UNITED STATES PATENT AND TRADEMARK OFFICE

APPLICATION NO.	FILING DATE	FIRST NAMED INVENTOR	ATTORNEY DOCKET NO.	CONFIRMATION NO.
09/768,271	01/25/2001	Tsukasa Yajima	PNET.009D	3802
20987 7590 01/05/2007 VOLENTINE FRANCOS, & WHITT PLLC ONE FREEDOM SQUARE 11951 FREEDOM DRIVE SUITE 1260 RESTON, VA 20190			EXAMINER MAI, ANH D	
			ART UNIT	PAPER NUMBER
			2814	
SHORTENED STATUTORY PERIOD OF RESPONSE		MAIL DATE	DELIVERY MODE	
3 MONTHS		01/05/2007	PAPER

Office Action Summary	Application No.	Applicant(s)	
	09/768,271	YAJIMA, TSUKASA	
	Examiner	Art Unit	
	Anh D. Mai	2814

DETAILED ACTION

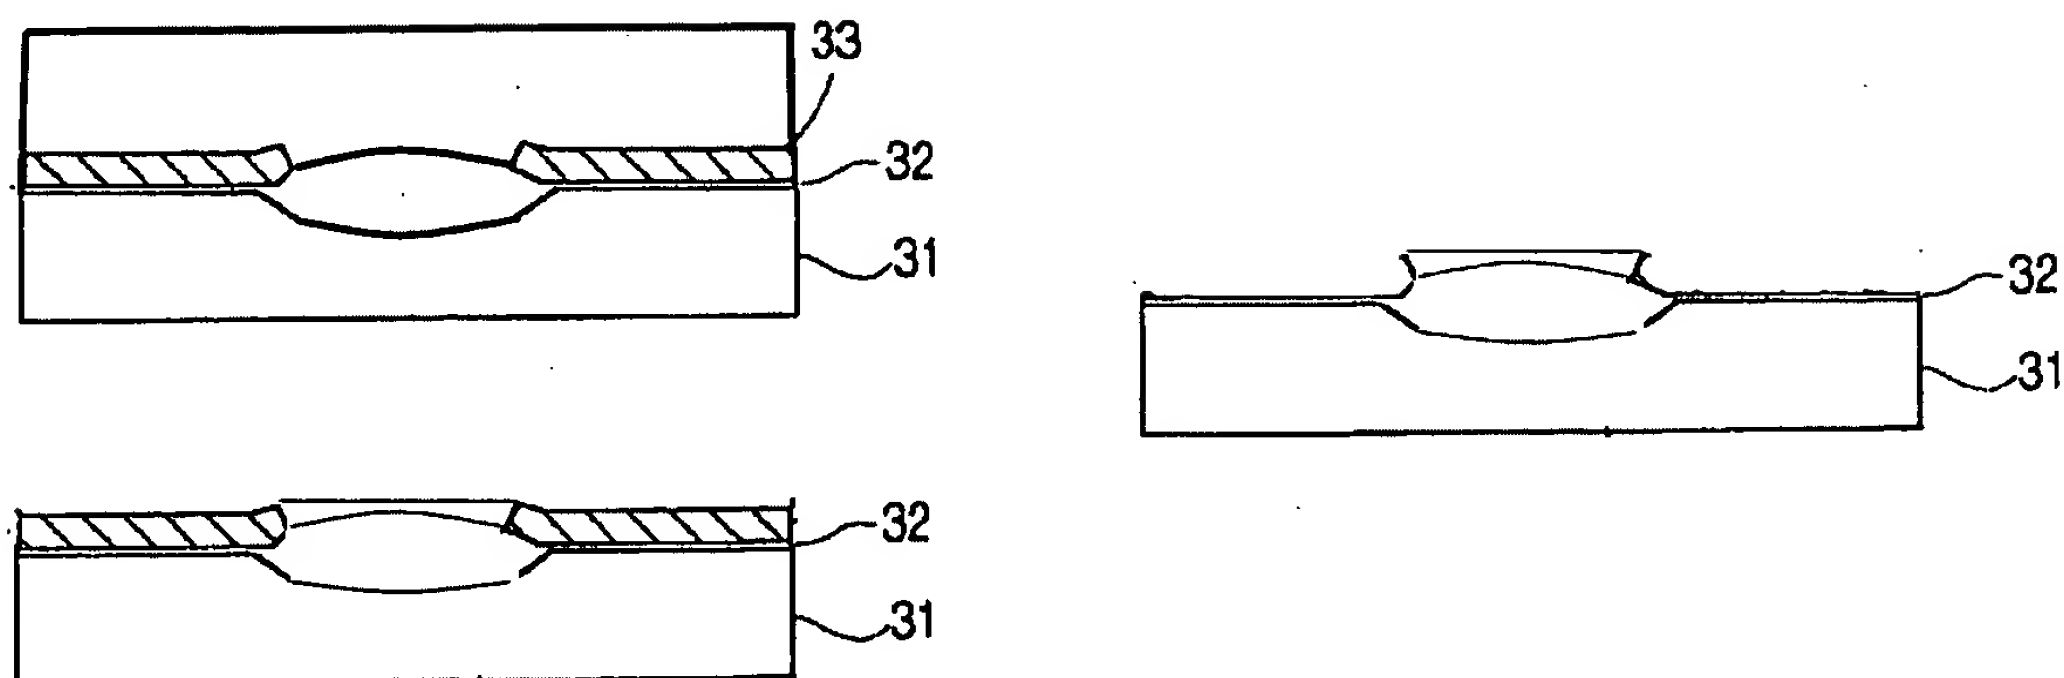
Regarding the new matter: the protective layer “as having substantially uniform thickness”, Applicant asserts: since the protective layer of the present application *is planarized*, the protective layer should be understood as having substantially uniform thickness, *although not exactly*.

The “although not exactly” is the most correct.

The convex nature of the field oxide are well known in the art and has been recognized by the Applicant. As illustrated above, after the planarization, the middle portion of the protective layer should be thinner than the rest of the protective layer on the field oxide, regardless of the protective has been formed at the edge or not.

Planarizing the polysilicon layer 11 on the field oxide 34 only flattens the surface, not forming an uniform thickness.

The above assertion clearly shows that the Applicant could not distinguish between "uniform thickness" and "planar surface". Since planarize the top surface only results in flattening the top surface. In the instant case, as shown in the illustration above, planarizing the top surface of the polysilicon layer on a field oxide (LOCOS) only results in flattening surface, not uniform thickness.

The rejection is therefore, maintained.
